# AirLINE SP

Type 8647 valve island – ready for the future!

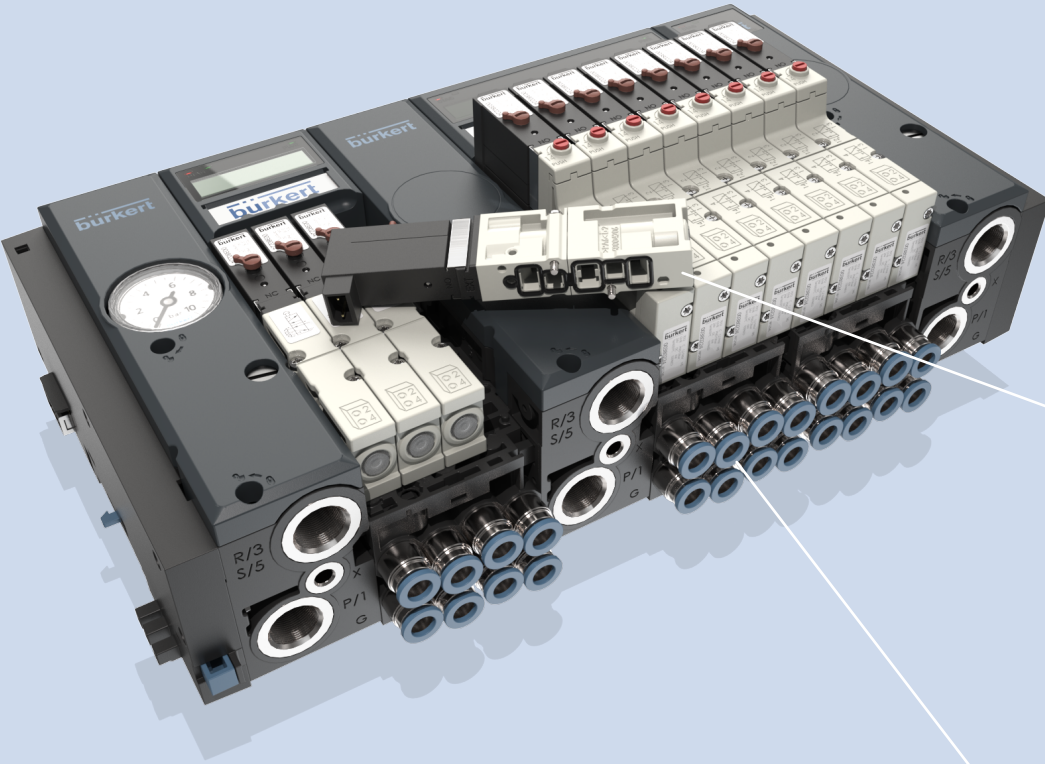
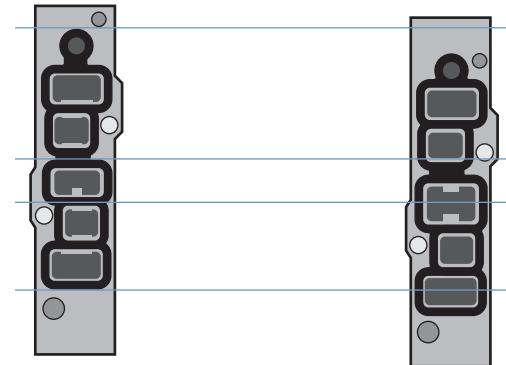
Single valves  
(Changed connection diagram due to different size of the channels)

**Project planning:** software unchanged

**Dimensions:** unchanged (connections 5 mm longer)

**Spare parts/compatibility:** due to further developments in pneumatics and consistent project planning, there is no backward compatibility on the pneumatic side.

Flow rate reduction  
(for HotSwap and non-return function)
